***SPECIAL  
BOARD OF COMMISSIONERS  
AGENDA  
Tuesday, July 7, 2015 - 6:30 PM***

***Caucus – Final Plan - Villanova University Housing Project***

RE: Villanova University  
Lancaster Avenue Housing, Related Parking Improvements, and  
Performing Arts Center  
Final Land Development Plan  
**Review No. 1 (REVISED)**  
RETTEW Project No. 101442003

Gannett Fleming, Inc. has completed a review of the Villanova University Lancaster Avenue Housing Final Plan for compliance with the Radnor Township Code. This Final Plan was reviewed for conformance with Zoning, Subdivision and Land Development, Stormwater Management, and other applicable codes of the Township of Radnor. A review was also completed for the accompanying plans for the West Lancaster Parking Lot, Pike Field Garage, the Performing Arts Center, and the Church Walk Bridge submitted in support of the Lancaster Avenue Housing Land Development.

C2.1

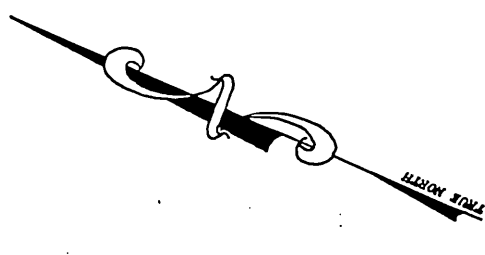
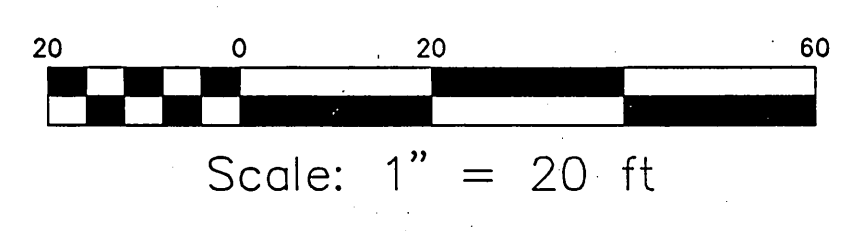
1. Sheet 5 of 32 (C2.1):
  - i. Provide an accessible route or eliminate the proposed steps/risers along the sidewalk located between Geraghty and Griffin Hall.

1. Sheet 5 of 32 (C2.1):
  - i. Provide an accessible route or eliminate the proposed steps/risers along the sidewalk located between Geraghty and Griffin Hall. **We will comply by providing a ramp in addition to the staircases which will be preserved.**

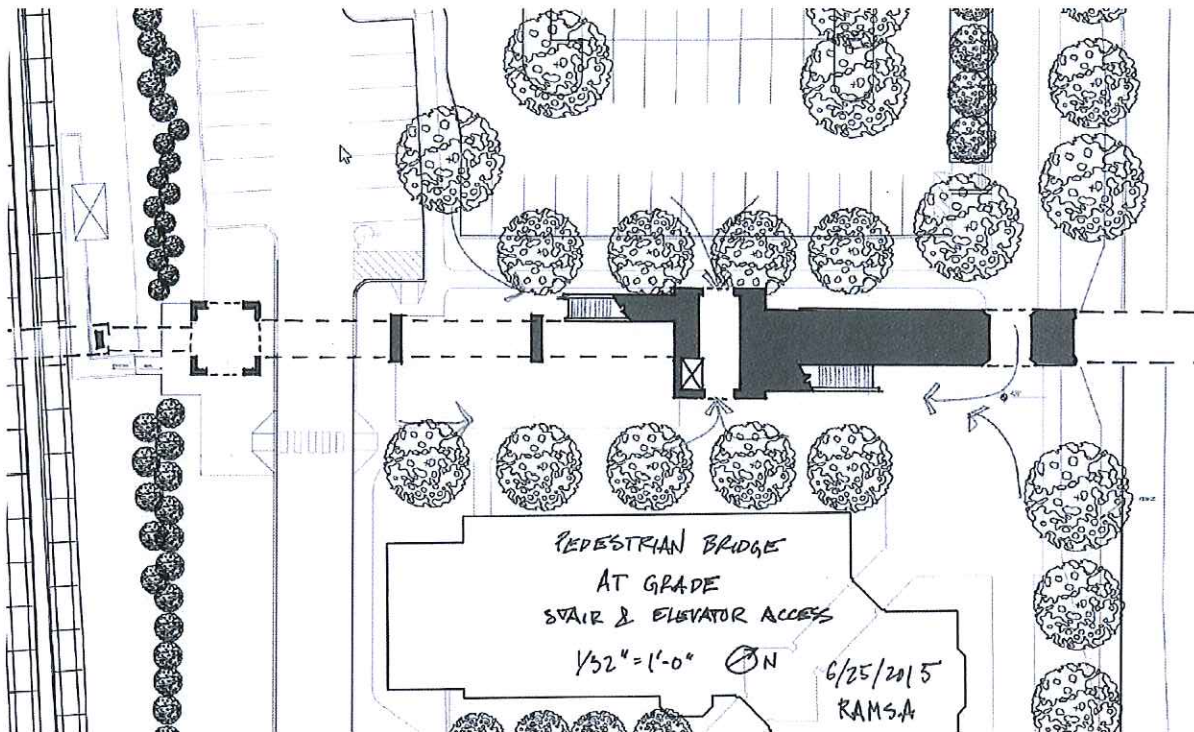
2. Sheet 6 of 32 (C2.2):
  - i. Revise the phasing for the construction of the fence across Church Walk to a later phase (Phase 2B). The existing Church Walk driveway will need to be fully operational during Phases 1 and 2A and the proposed fence extends across a portion of the driveway. **We will comply by clarifying the phasing of the fence construction, as noted in the comment.**

- ii. Revise the phasing for the construction of the fence on the north side of Lancaster Avenue, to follow the completion of the Pedestrian Bridge. The Church Walk Pedestrian Access/or the proposed temporary pedestrian route must remain accessible during the WLA construction. **We will comply by clarifying the phasing of the fence construction, while accounting for the**

proposed temporary pedestrian route during the Pedestrian Bridge construction.
